Sample Data Room Assessment

EXECUTIVE SUMMARY

The Vision Data Room in Little Rock, AR was surveyed on October 14, 2017. The observations and recommendations contained in this report are based upon that site visit. The site serves as the primary data center for Vision Data. We were hired to give a report of the current status of this facility with an emphasis on making changes so that the room would have redundant air. This report will be based on the current as is status.

Drawing 1. Current Data Room Layout

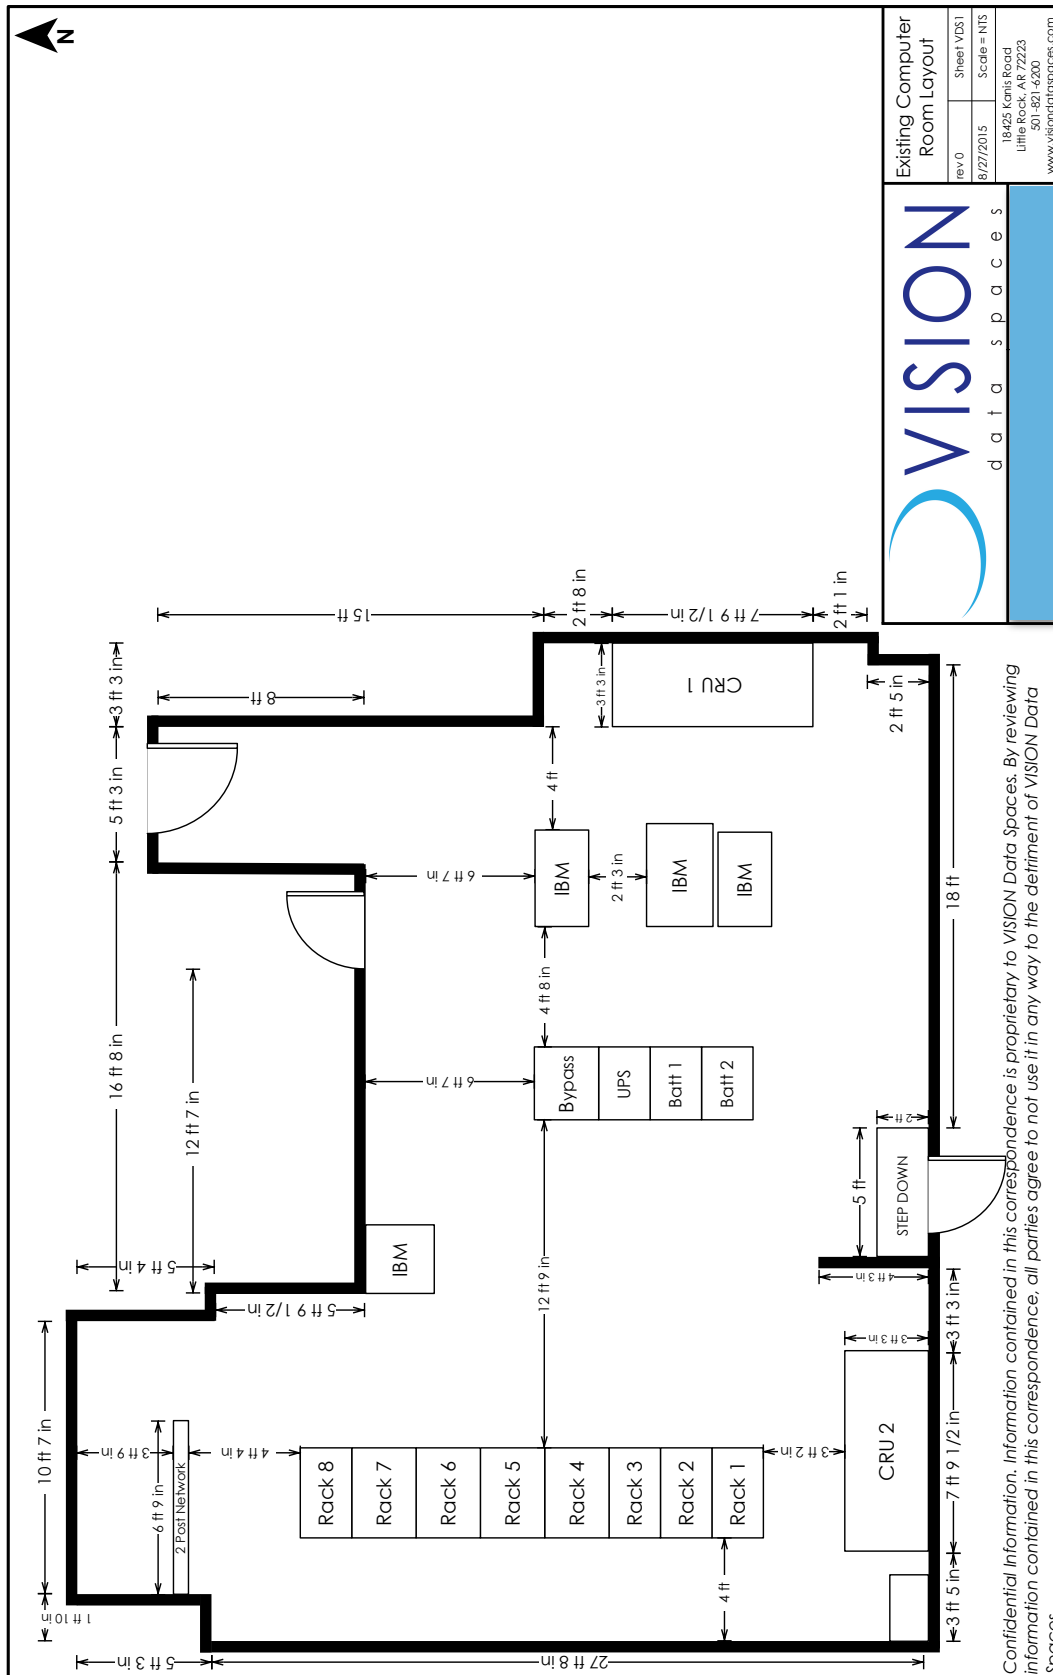
CURRENT CONDITIONS. The existing room is cooled with two 16 Ton Data Aire CRAC (Series DAAD-1632-C) cooling units. These are down flow units on a 8 inch raised floor. The unit is a DX unit, with condensers on the roof, as well as chill water cooling, dual coils. Maximum air flow is 8000 CFM per unit. We observed one unit using the DX coil and the other using the chill water coil. The two units have to both be running to adequately cool the current IT load and space. This is due to an inadequate air delivery system. The floor height is not capable of delivering the capacity of the two 16 Ton units. The cooling capacity of just one of the units is capable of cooling the room if you could get maximum output, which is limited by floor height. In our opinion, it is not practical to raise the floor or try to duct the units to maximize capacity.

CURRENT CONDITIONS. The existing air flow is not adequate to maximize the capabilities of the two 16 Ton CRAC units. The 8 inch raised floor has insufficient plenum volume to handle the 8000 CFM of air flow the Data Aires are capable of outputting. This is why it takes both unit running to cool the room. Tiles are placed in appropriate locations for best cooling practices. However, tile placement will not change the air delivery system.

RECOMMENDATIONS. Install new InRow chilled water cooling units as shown on proposed room layout drawing (2). The existing system will be utilized as the backup system.

- Add six (6) InRow chill water cooling units that would supply the primary cooling for the IT equipment. The existing system would be used for backup. Fail over circuits would be installed to start backup system in case of primary failure. Two additional racks would be required with recommended solution.

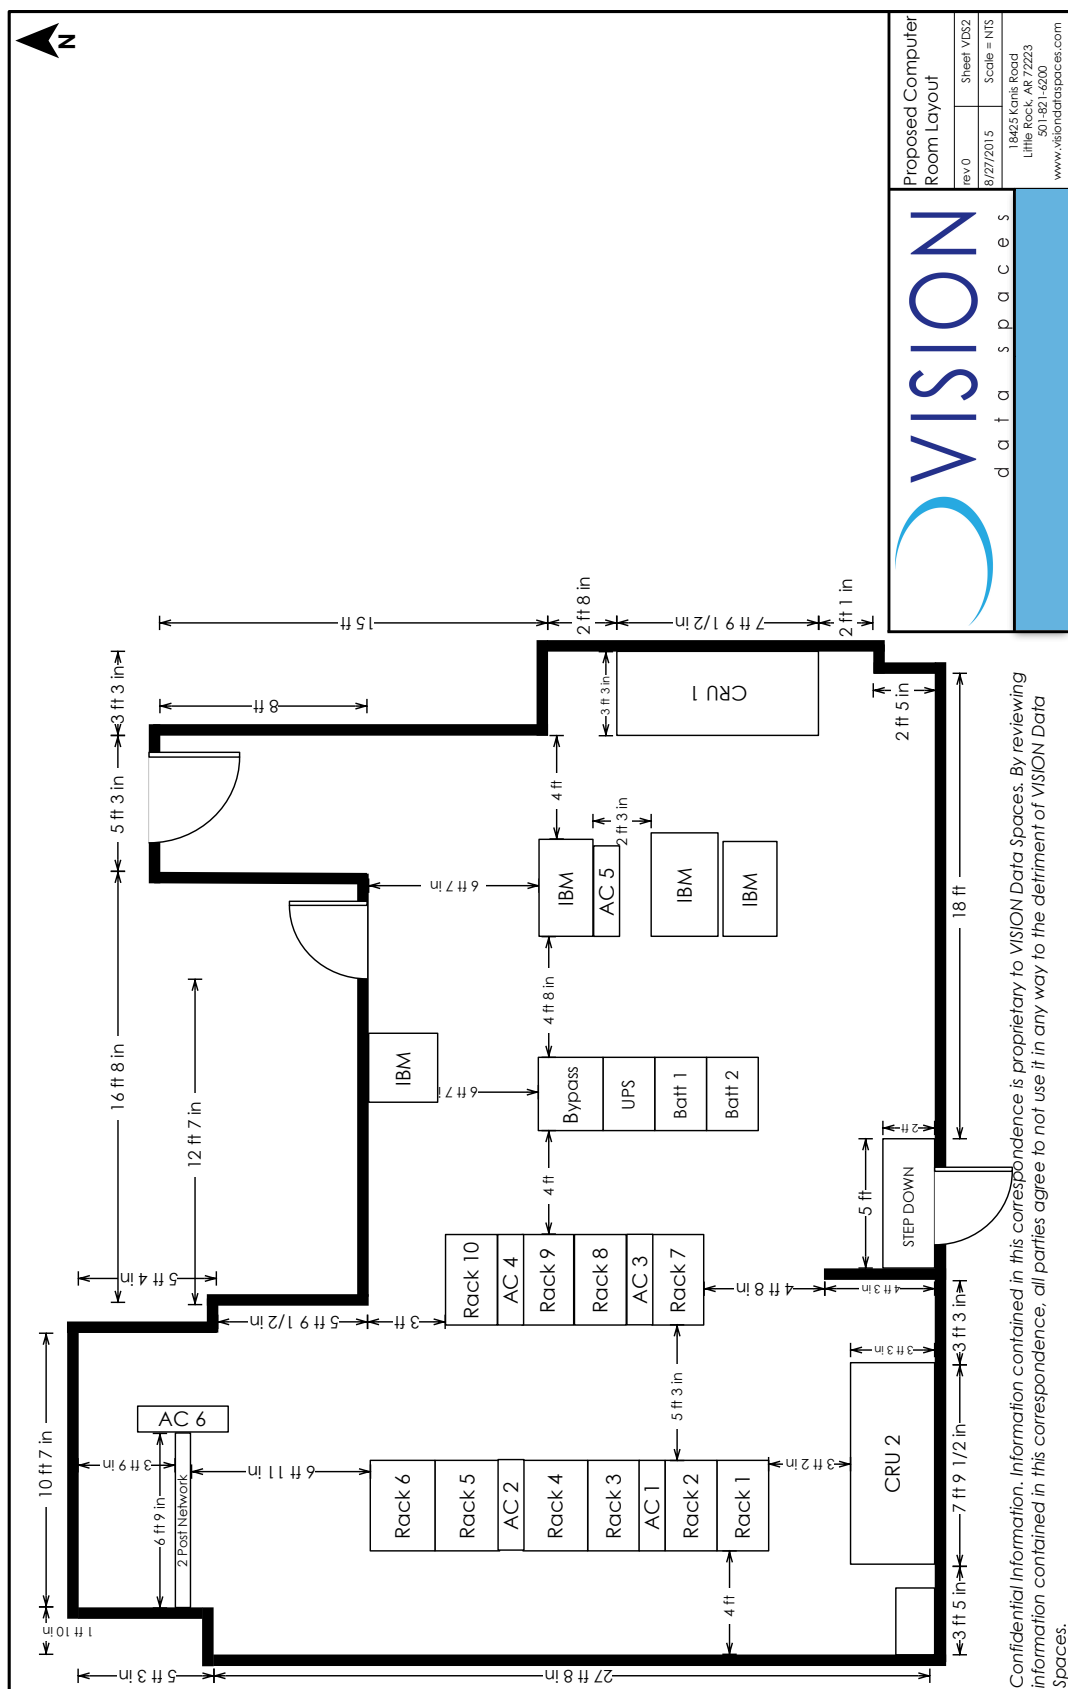
This section contains recommendations based upon the current conditions, anticipated growth, and the critical nature of the operation. The Critical Infrastructure Evaluation Matrix provides an overview of each area, the critical nature of that area, the recommended implementation time frame and the estimated cost associated with recommended changes or upgrades. A detail proposal can be offered if you want to implement any of these projects. Drawing 2 shows the proposed changes in the layout.

RECOMMENDATIONS. None unless Cooling System is upgraded. Layout would need to be similar to Proposed layout drawing

- Configure racks as shown on Proposed Layout Drawing 2.
